# Super-PON PMD Refinements

IEEE P802.3cs, June 4, 2020  
Liang Du (Google)

# Black link - downstream (informative)

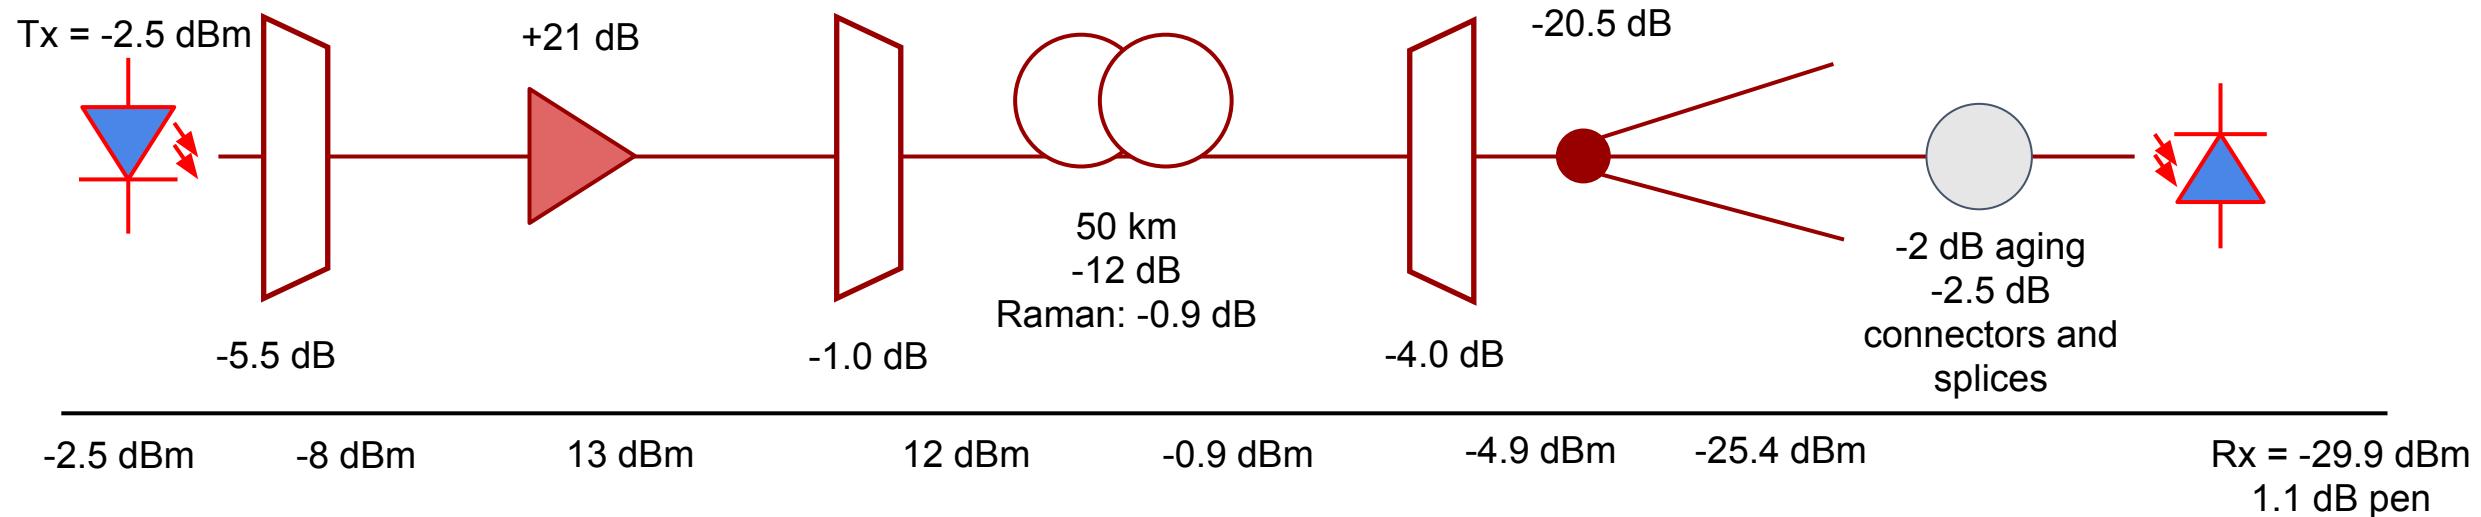
Gain  $\geq 21$  dB

Max power  $\geq 25$  dBm

NF  $\leq 12$  dB

Passband =  $\pm 15$  GHz

inband ripple = 1 dB

loss  $\leq 5.5$  dB

Temp range: 0 to 40 C

Passband = 1.6 THz

inband ripple = 0.5 dB

loss  $\leq 1.0$  dB

Passband =  $\pm 15$  GHz

inband ripple = 1 dB

loss  $\leq 4.0$  dB

Temp range: -40 to 65 C

# Black link - upstream (informative)

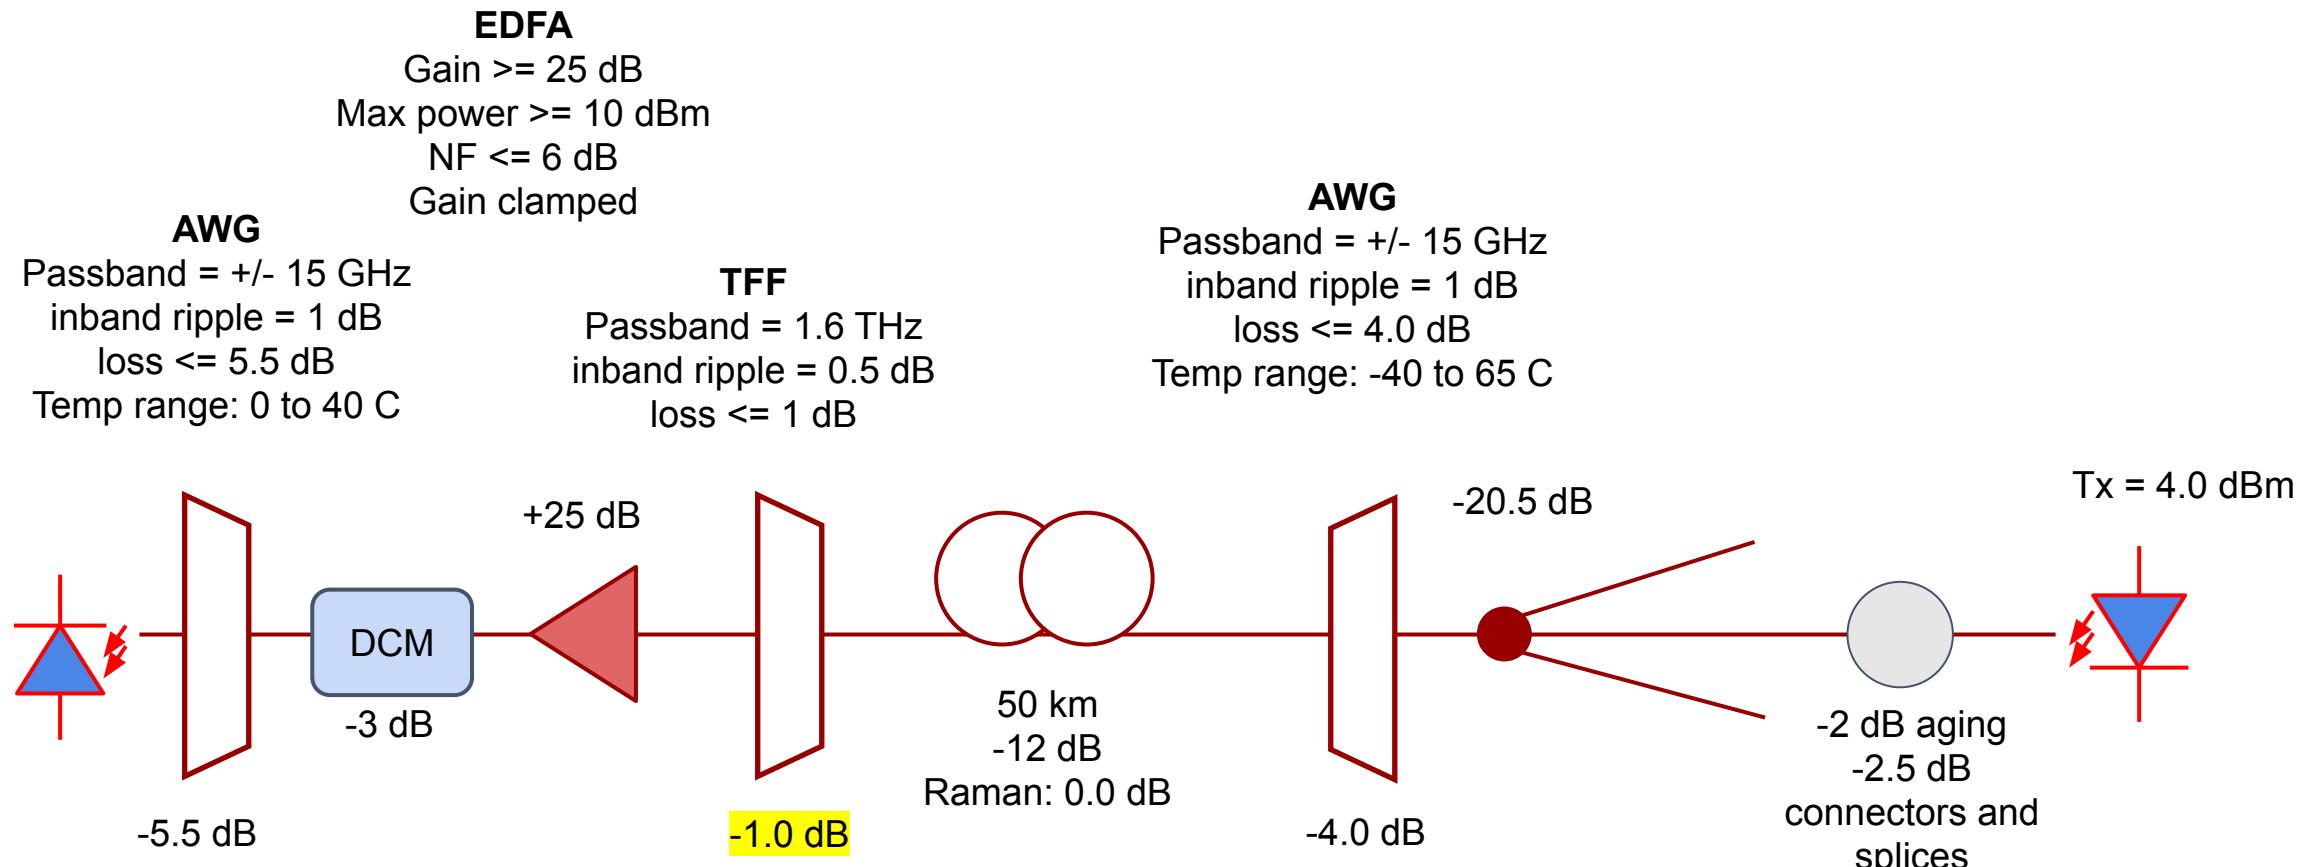
Rx = -21.5 dBm  
OSNR = 14 dB  
2.1 dB pen

-13 dBm  
OSNR = 14 dB

-38 dBm  
-1.0 dB

-25dBm  
-4.0 dB

-21 dBm  
-20.5 dB
